5 Name Of Dam: DAM ON THE HEADWATERS OF SQUALL CREEK  
3 Location: PATRICK COUNTY, VIRGINIA  
8 Inventory Number: VA 14104

# PHASE I INSPECTION REPORT NATIONAL DAM SAFETY PROGRAM

PREPARED BY  
NORFOLK DISTRICT CORPS OF ENGINEERS  
803 FRONT STREET  
NORFOLK, VIRGINIA 23510

FEBRUARY 1978

VIEW LOOKING DOWNSTREAM FROM CREST OF DAM - NOTE EROSION  
ON THE DOWNSTREAM SLOPE

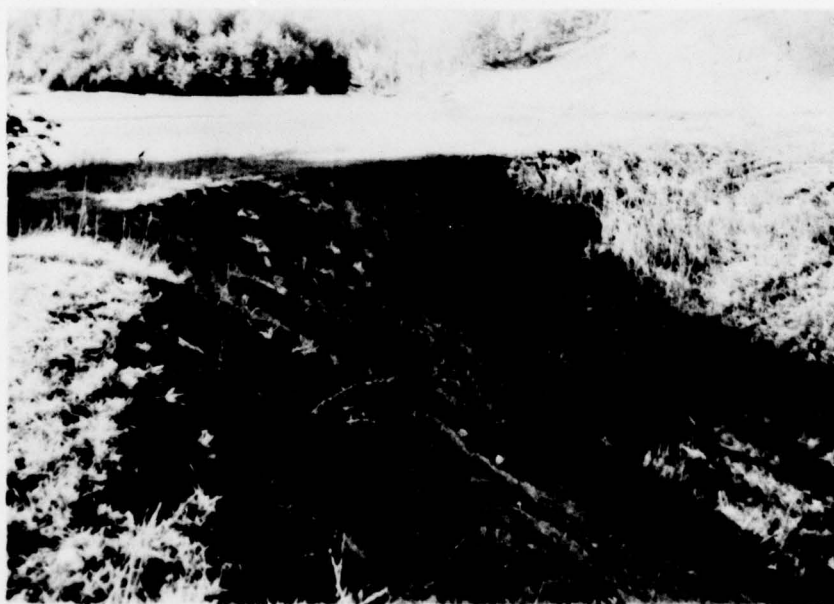
3.1.2.1 Embankment. The earth fill dam was constructed from local residual material which had been weathered from underlying schist or phyllite bedrock. The only sign of distress on the embankment was the severe erosion on the downstream slope. The erosion gullies ranging in depth from 6 inches to 3 feet were more pronounced near the abutment contacts where surface runoff was being channeled from the abutment slopes. Vegetative cover ranged from adequate near the dam crest to nonexistent in the areas of severe erosion. The visible portion of the upstream slope was 4h to 1v.

7.2 Remedial Measure. The severe erosion problem should be addressed immediately to prevent further slope deterioration. After filling and seeding the existing gullies, measures should be taken to prevent erosion while the vegetative cover is being established. In an effort to prevent further erosion, surface runoff from the adjacent abutments should be redirected away from the embankment slopes.
